**RE: EASTERN CREEK QUARTER - LOT 3 CONCEPT PLAN (SSD-10457)**

Ethos Urban has prepared this letter on behalf of Frasers Property Australia Pty. Ltd (Frasers) in response to the Department of Planning and Environment's request for information (RFI) letter dated 22 February 2022. It is accompanied by the following additional information provided by the relevant technical experts:

**Figure 1** Proposed Plan of Subdivision

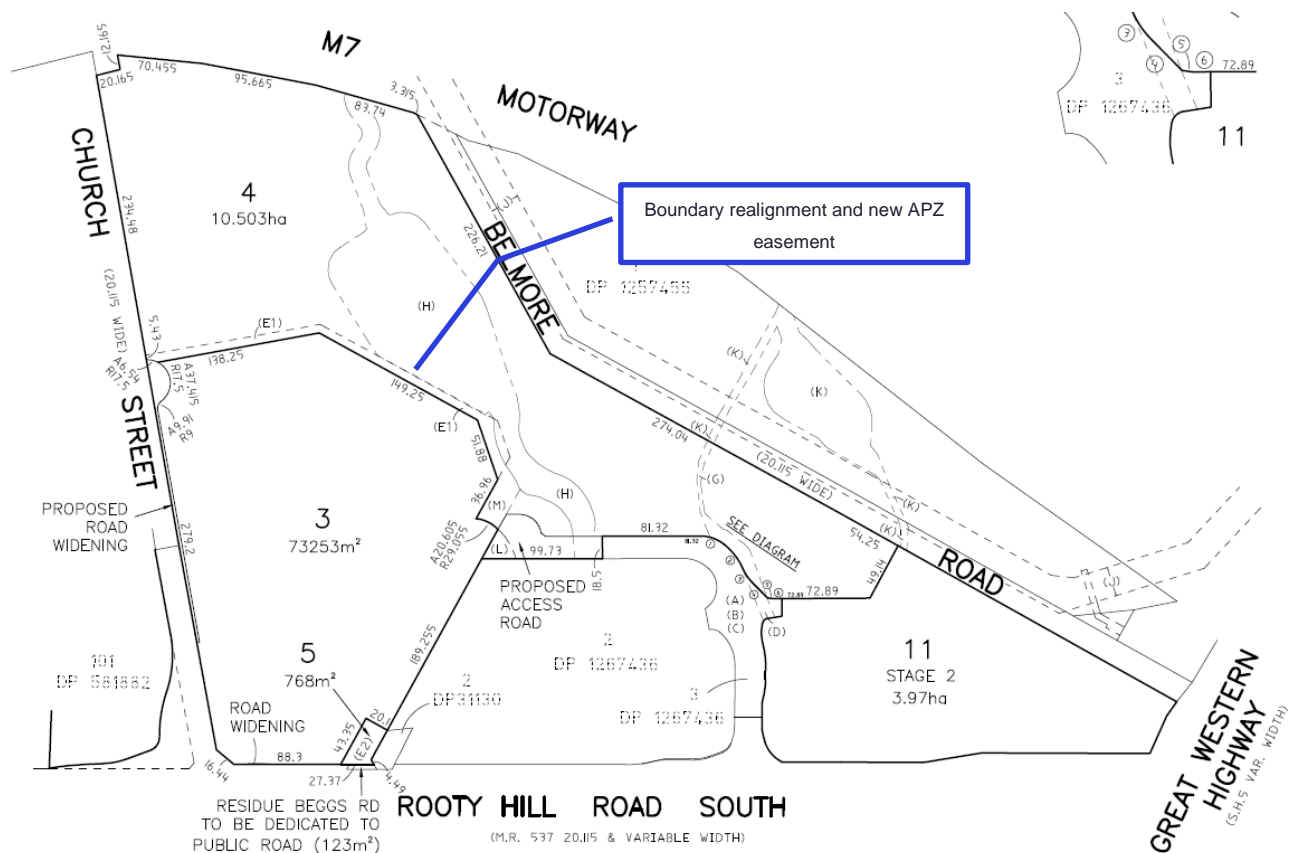
A new draft Plan of Subdivision is included at **Attachment L** which has been updated to reflect the proposed widening of Church Street to accommodate Council's design requirements for an industrial road and the realignment of Lot 101 to facilitate the 4-way intersection design (refer to extract at **Figure 1**). In addition, due to commercial arrangements between Frasers and the WSPT, the eastern boundary of the lot has moved west by 7m and a new easement is proposed along this boundary within Lot 4 to accommodate the APZ that was previously located completely within the site. The building location will remain in the same place which results in new setbacks to the lot boundary along this frontage, however, the overall APZ and separation to the parklands remains the same via the proposed easement. The overall site area of the lot will be reduced to approximately 7.32ha.

**Figure 2** Concept as Submitted

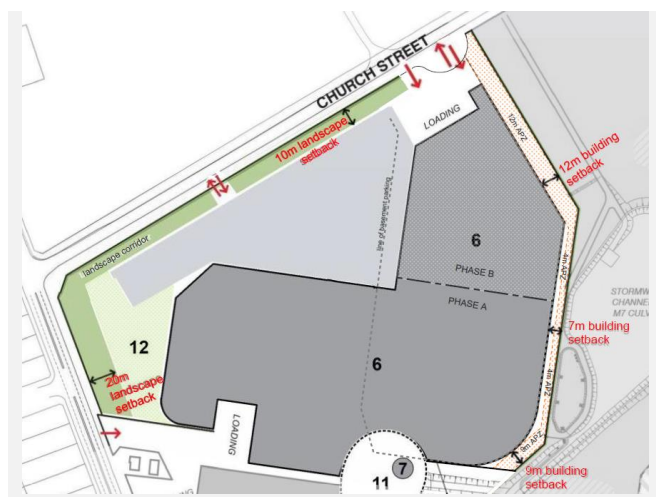
The revised plan of subdivision will require changes to the Concept Plan (**Attachment M**) and associated Design Guidelines (**Attachment N**). As shown at **Figures 2** and **3**, the landscape setbacks to both Rooty Hill Road South and Church Street will not be affected by the revised subdivision layout, and there will be an additional portion of landscape area at the intersection as a result of the Church Street realignment. The setbacks along the eastern frontage will decrease to reflect the revised boundary alignment, however, a new easement will provide for the same overall APZ and separation distance to the parklands as per the previous design.

- A modification to the eastern frontage to accommodate target tenants' requirements and to relocate the multi-purpose court to a more central location;
- Reconfiguration to the shape of ECQ social;
- Realignment of the Phase A / Phase B boundary; and
- Amend the turning circle at the end of Goldsbro Glade to a three point turn.
